PLAYGROUND INSPECTION REPORT

Site Location Address: Bryanston School Park - 15237 Thirteen Mile Rd, Bryanston, Ontario, N0M 2A0

Report: Annual comprehensive

Equipment installed prior to latest version of CSA Z614

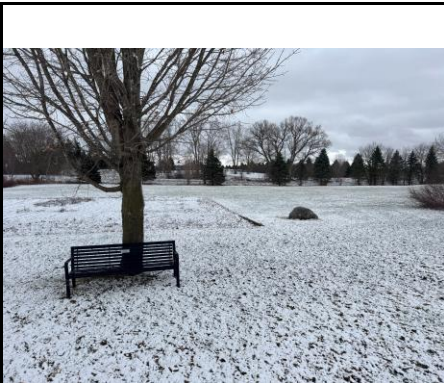
Playgrounds are required to comply with the Standard in place at the time of installation.

It is a good standard of care to maintain all playground equipment as per the new data presented in the most recent version of CSA Z614.
